A380 Engine Driven Pump Status Update

Product Support Manager
Bedhampton FMC Hydraulics

Introduction of New Model PV3-300-31P

PV3-300-31P Thermal Heat Guard

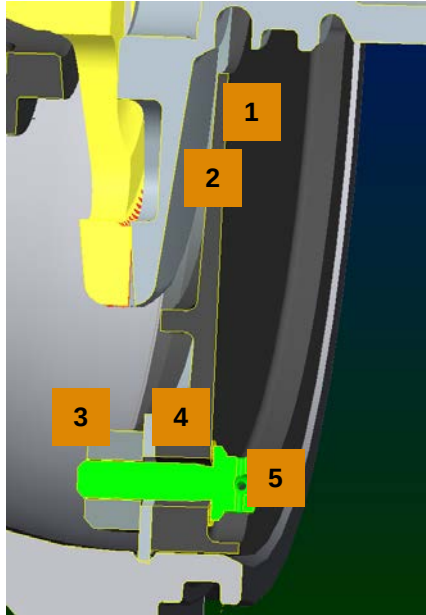
Incorporates new thermal barrier

Reduce heat transfer to the EDP clutch cavity from the Accessory Gear Box (AGB)

The thermal barrier is intended to resist high temperature blown air from the AGB

Combat the formation of thermally stressed fluid inside the mounting flange cavity

PV3-300-31P Thermal Barrier - Detail

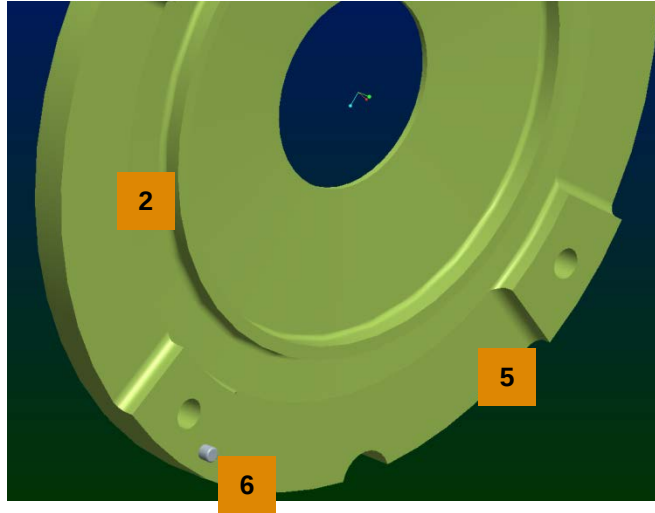
1. Thermal barrier S/A (3022148-205)

1	Material (30% GF filled PAI)
2	Boss (stiffens and reduces air flow)
3	Single drainage hole
4	Alignment groove feature (visual checking aid)
5	Weight saving cut outs
6	Pin to Poka-Yoke assembly

PV3-300-31P Coupling Shaft - Detail

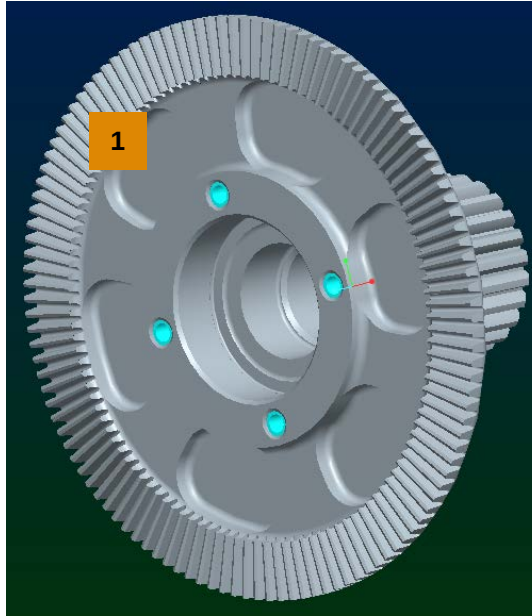
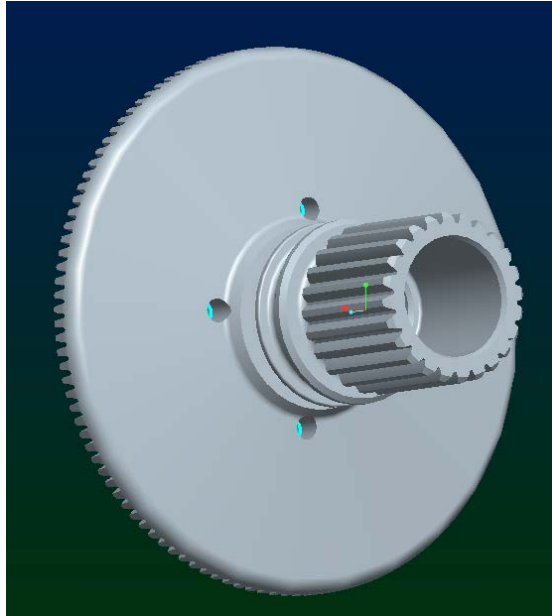
2. Coupling shaft S/A (3022148-204)

- 1** Through holes now pocketed
(reduces air flow into clutch cavity)

PV3-300-31P Guard Retainer - Detail

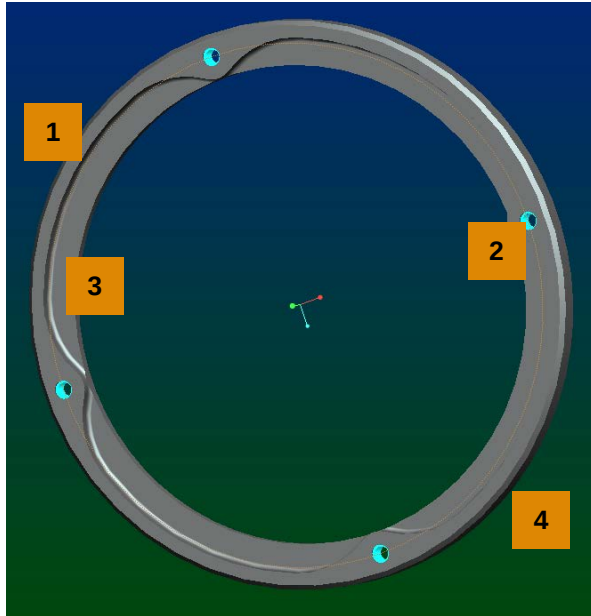
3. Guard retainer S/A (3022148-203)

PV3-300-31P Sprung Retainer - Detail

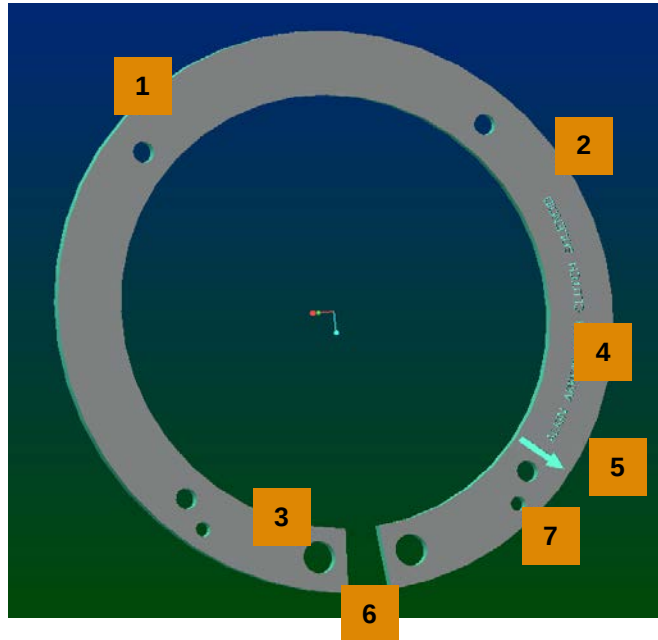
4. Sprung retainer (3022148-308)
